Historic District Review Committee

Staff Report
June 14, 2010

CAPP 2010-0015 Swezey: Remove and Replace Sunroom in the Goose Creek Historic District: PIN 388-35-3823.

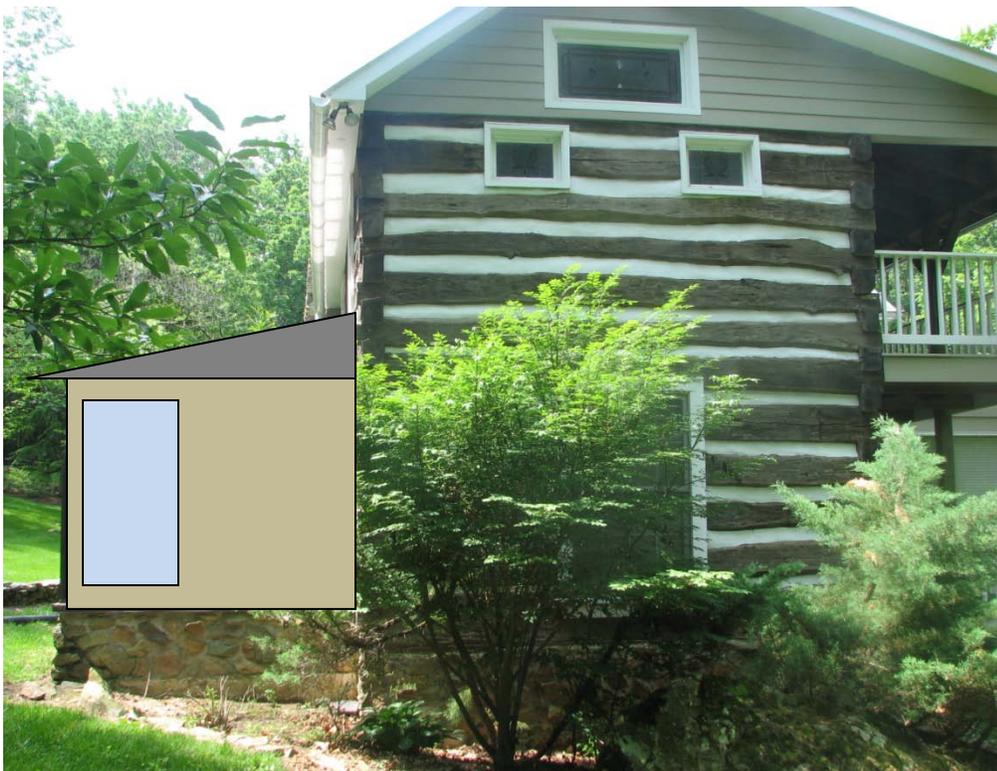
The applicant proposes to construct a frame shed-roofed sunroom on the front elevation of the log portion of the building. It will be the same size of the sunroom proposed for demolition and constructed on the existing stone-faced foundation. The dimensions of the existing foundation are approximately 14' by 8'. A string of 4 double hung windows will be installed across the front and a single window on each side.

The proposed sunroom is on the front of the building; however, it will replace a very modern sunroom with an addition that is more sympathetic to the historic house and design. Furthermore, the house is barely visible from the road. The proposed sunroom is also subordinate to the main block in other ways, as the shed roof is shorter, the depth is just over 8', and the walls are recessed from the sides of the log portion.

The ratio of solids to voids for the proposed sunroom is appropriate since the proposed addition is a sunroom. The string of windows across the front, in particular, conveys the purpose of the addition.

The shed roof will have an 8/12 pitch and a 1' 5" overhang. It will be standing seam metal pre-painted dark bronze. Both the pitch and roof type and color match the main roof on the residence, meeting the *Goose Creek Guidelines*. However, since the proposed addition roof pitch will match the existing building, it will cover a window in the second story. **Although the applicant intends to maintain the window inside the sunroom, covering the second story window does not meeting the Guidelines for Existing Buildings. Blocking existing windows, particularly on the primary elevation, is identified as an Inappropriate Treatment (*Goose Creek Guidelines, Guidelines for Existing Structures: Windows, Inappropriate Treatments 4 and 7, p. 107*).**

Since the sunroom could also be considered an enclosed porch, designing the addition with a low-angled hipped or shed roof more typical of a porch would be appropriate. This option would allow the second story window to remain unblocked. Furthermore, the lower roof would be less visible from Mt. Gilead Road. Staff recommends that the applicant consider redesigning the sunroom with a lower-angled roof. Staff notes that covering or obscuring the window sill and exterior frame should also be avoided.

The proposed window trim and corner boards will be made of Azek PVC trim and painted white. Azek can be worked and painted, as well as has the appearance of wood; therefore it meets the Guidelines for Substitute Materials. The trim will be 3/4" thick. Widths were not provided. **Based on the plans, it appears that the dimensions and design of the simple trim meets the Guidelines; however, staff requests that the applicant provide widths at or before the HDRC meeting for Staff to evaluate (Goose Creek Guidelines, Guidelines for New Construction: Windows and Doors, Guideline 11, p. 73; Guidelines for Materials: Composite Trim Materials: Guidelines 1 - 3, p.133).**

Staff recommends deferral of the application in order to give the applicant an opportunity to redesign the proposed sunroom with a lower pitched roof that will allow for the second story window to remain unblocked.
